**LAKE PONTCHARTRAIN, LA.
AND VICINITY
LAKE PONTCHARTRAIN
HIGH LEVEL PLAN**

**DESIGN MEMORANDUM NO. 19
GENERAL DESIGN**

**ORLEANS AVENUE
OUTFALL CANAL**

ENGINEERING CORRESPONDENCE LOG

FIGURE 7

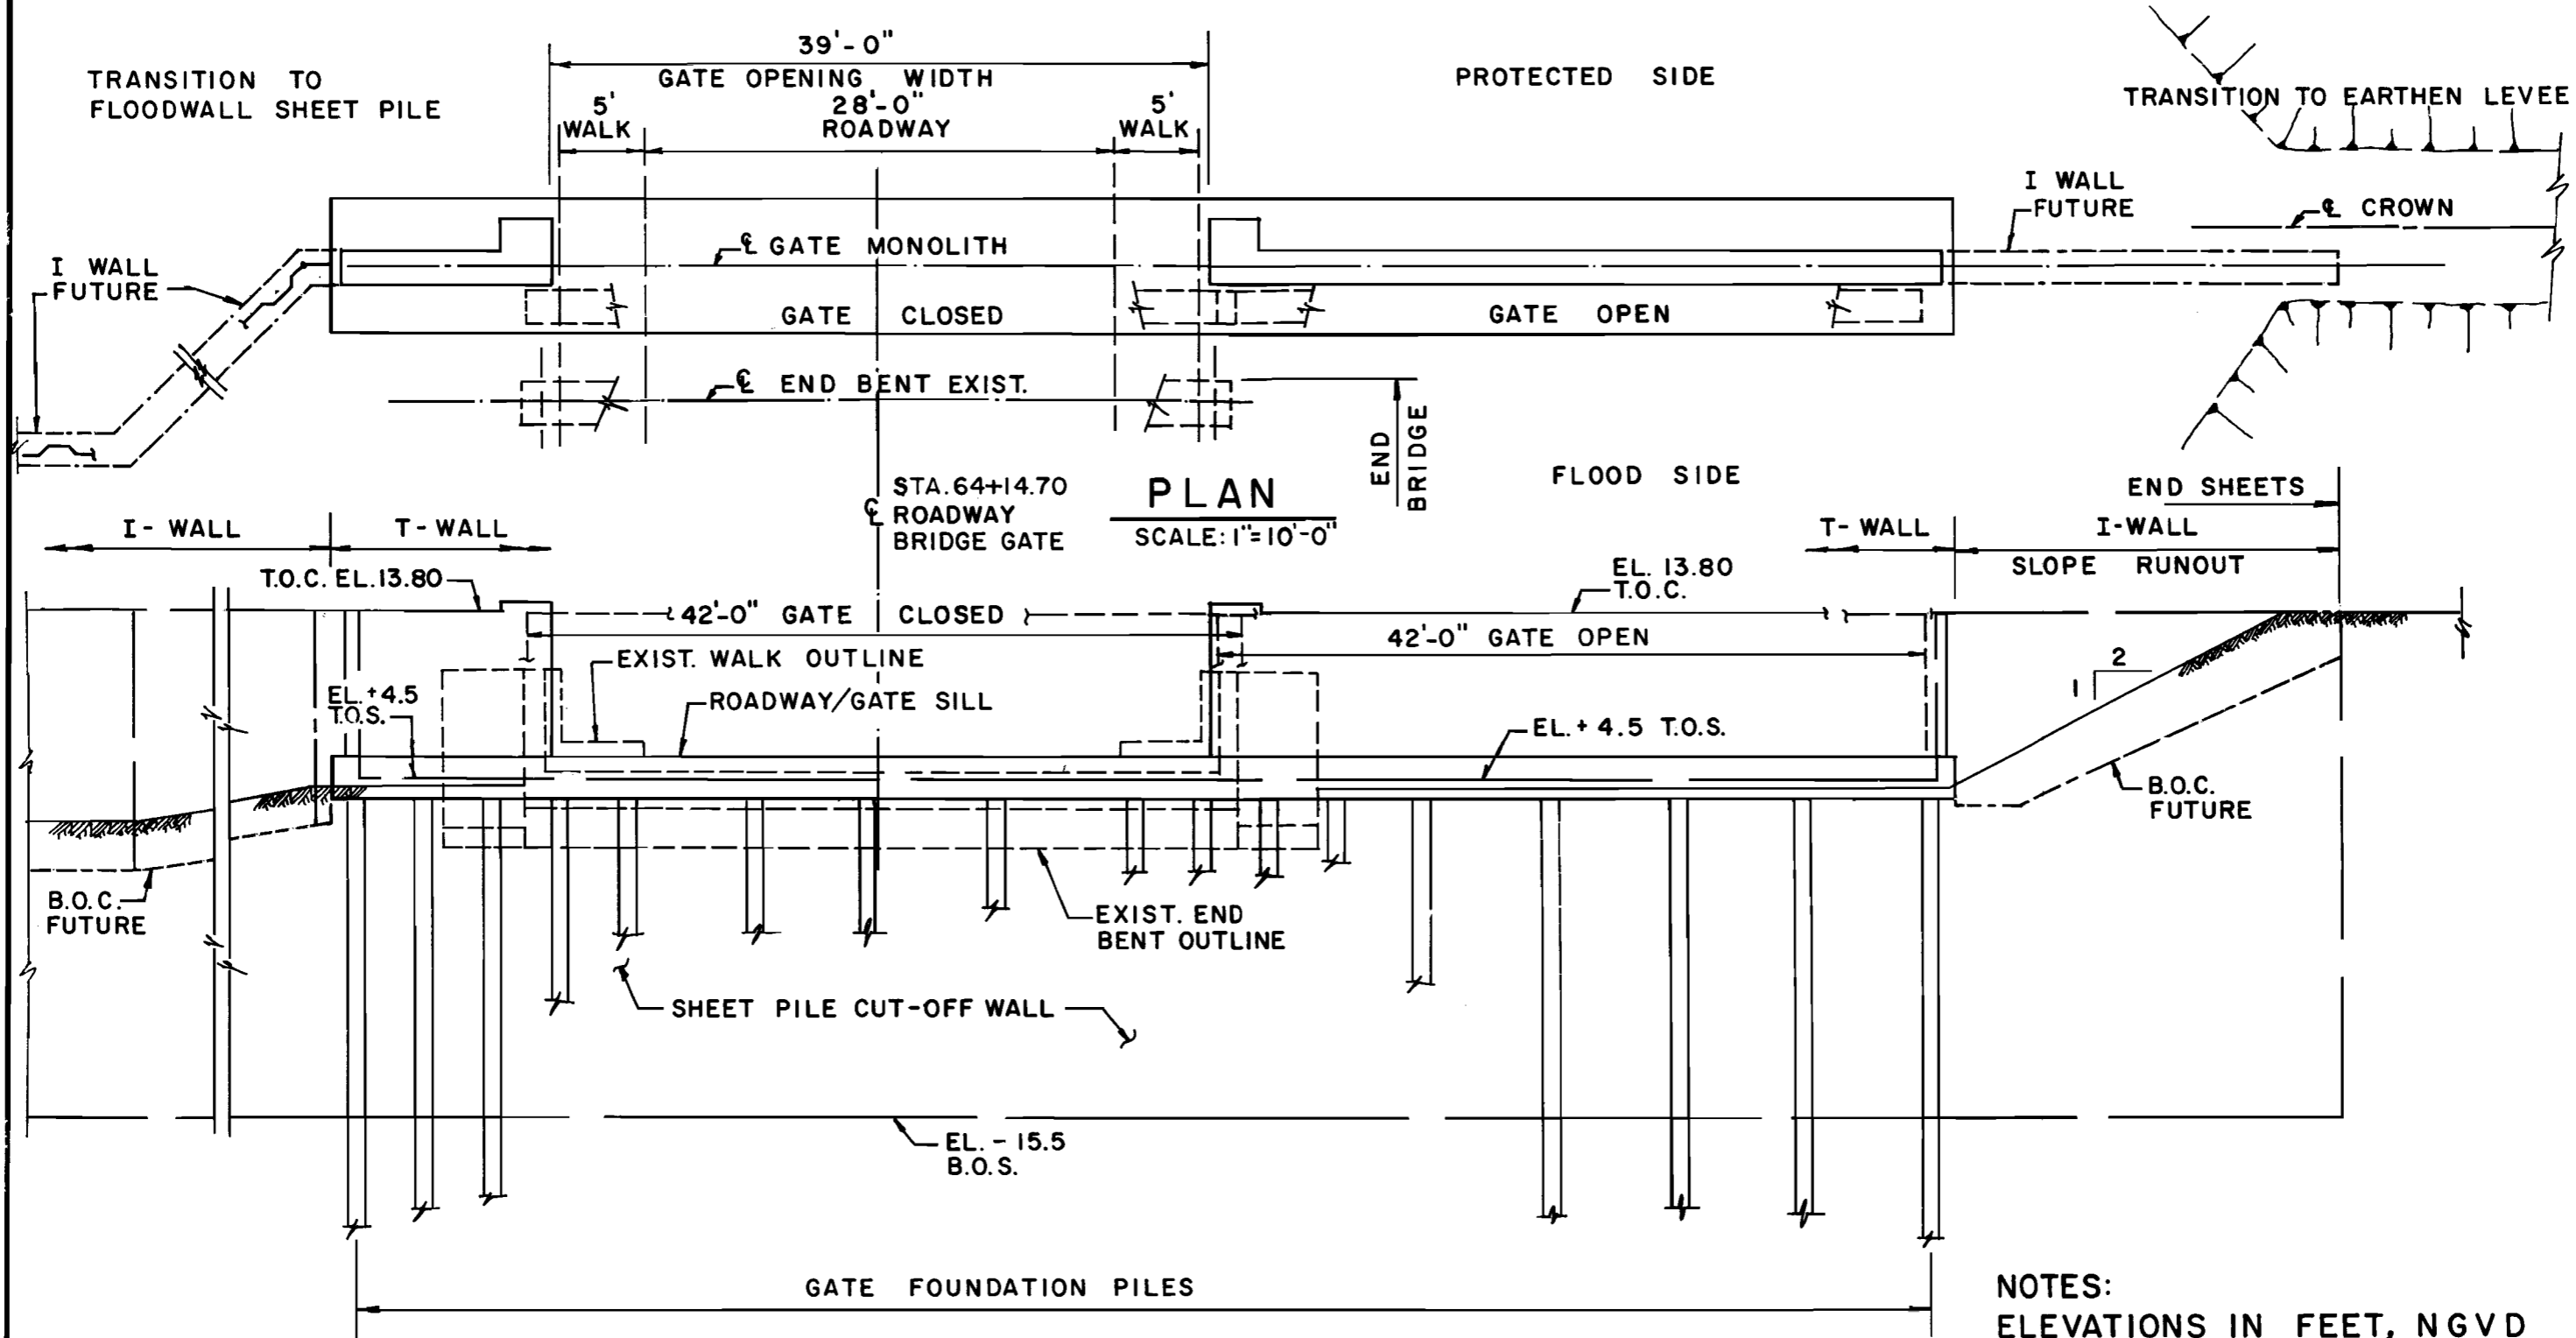
25. Reference figure 7, a. - It is suggested that another alternative be investigated for storing the roller gate. In some cases, we have found that an I-wall in combination with an adjacent pile-founded concrete slab is more economical than a pile-founded T-wall. The additional

26. Reference figure 7, b. - A stabilization slab should be added beneath the T-wall monolith(s). The NOD normally provides a 4-inch thick stabilization slab.

FIGURE 8

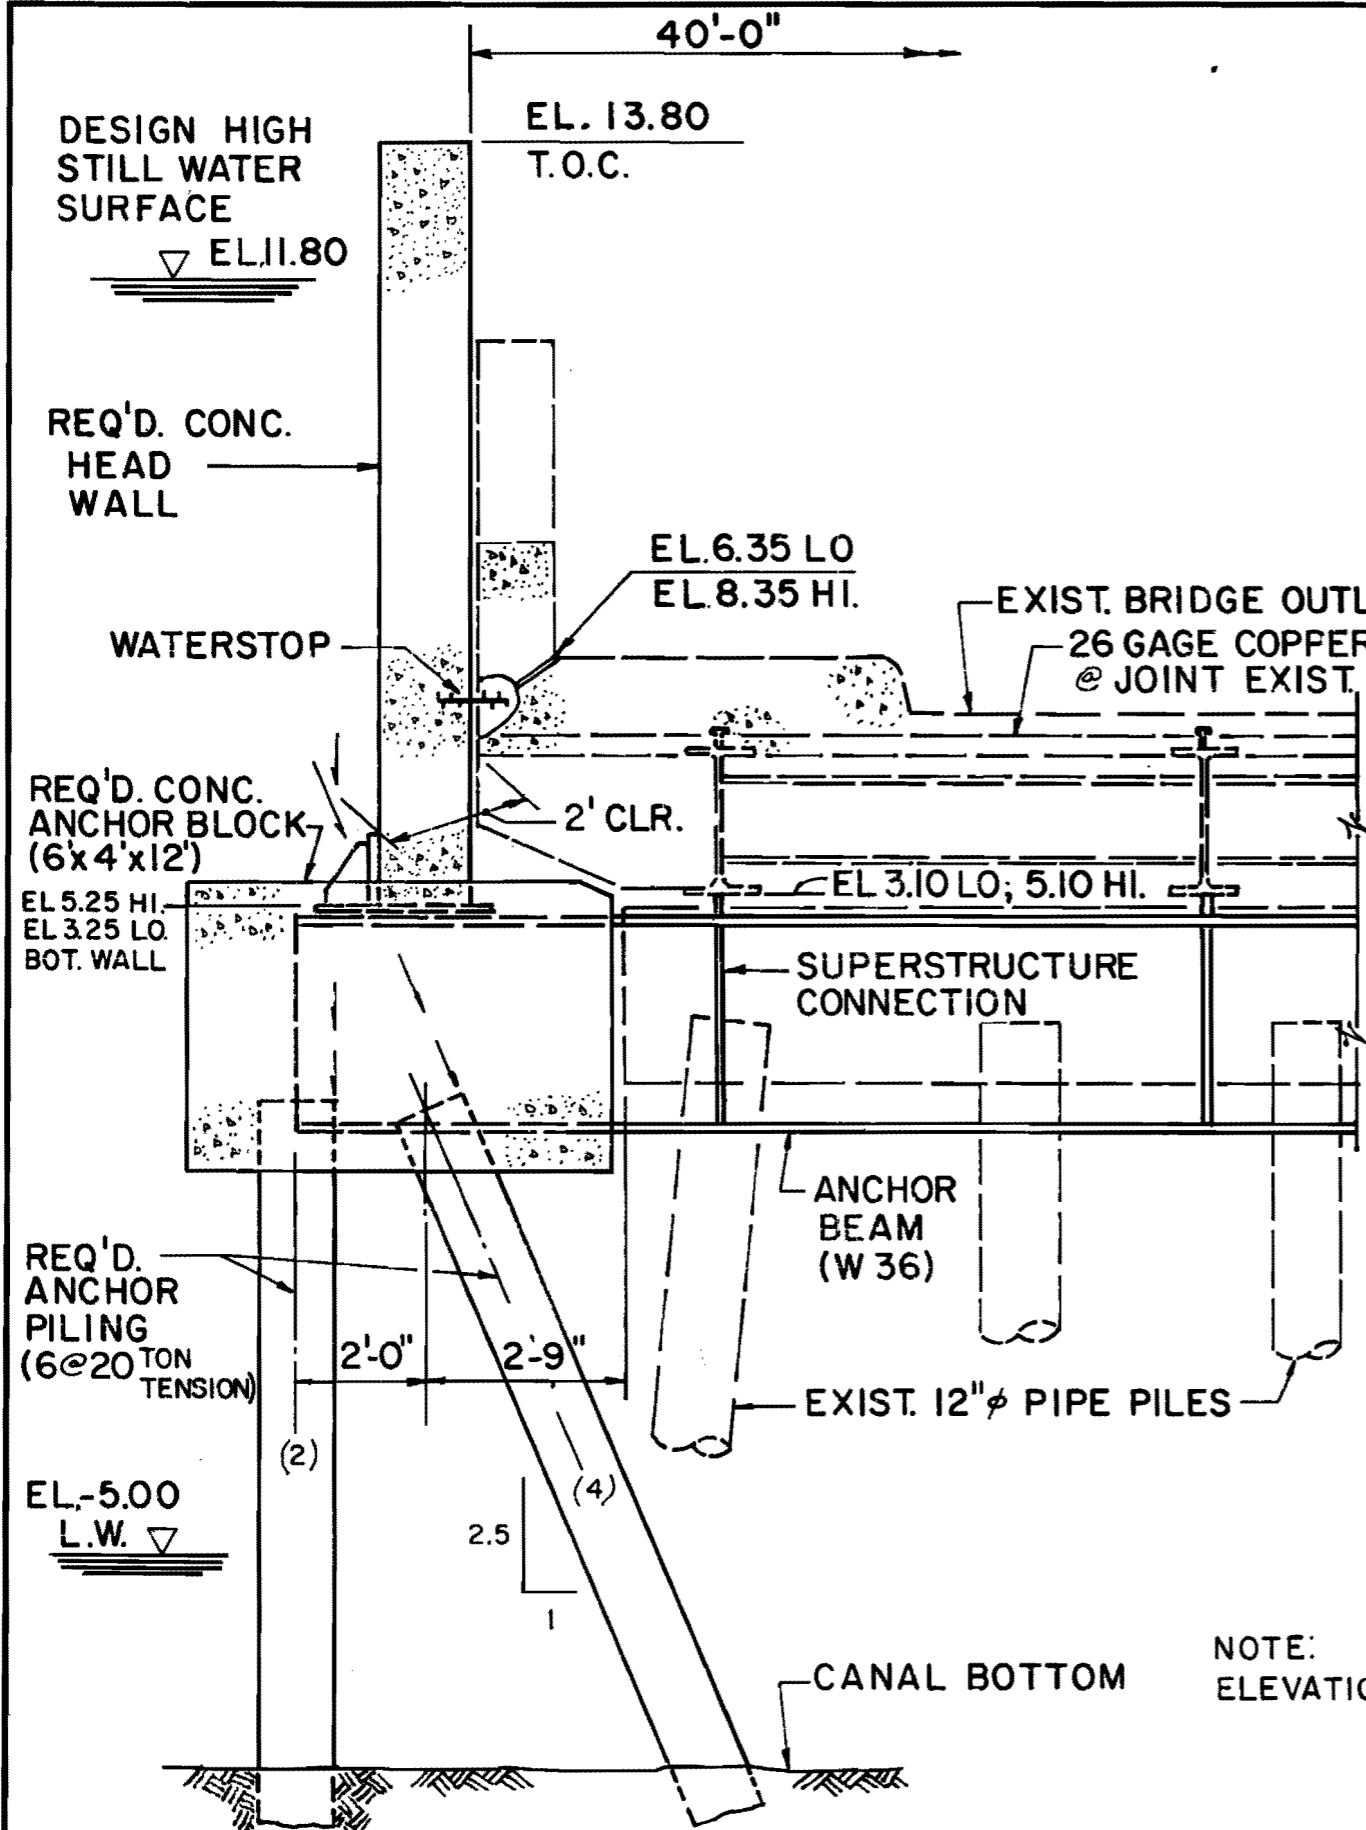
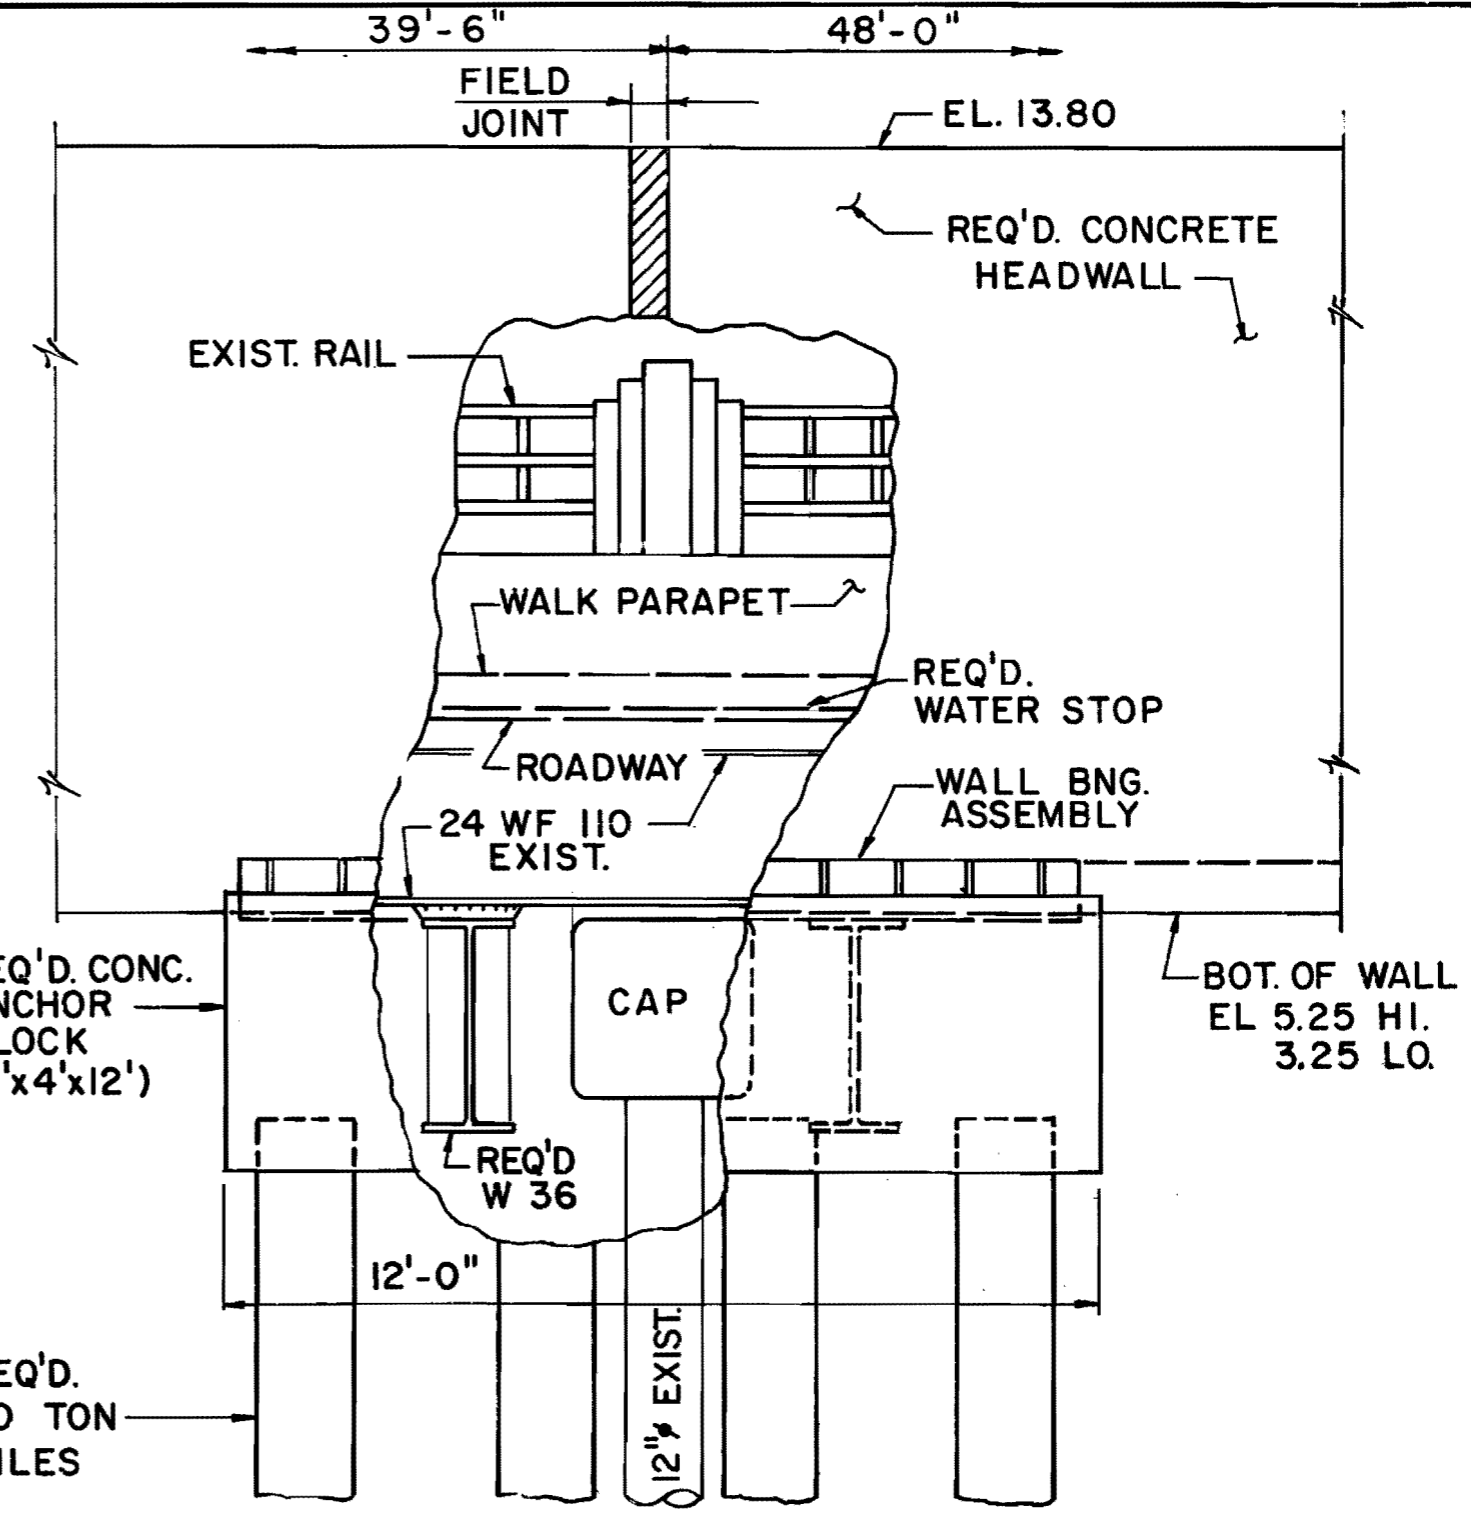
28. Reference figure 8-

(a) The design depicted in Figure 8 has been abandoned and a new bridge modification design is being prepared which will not include copper waterstop.
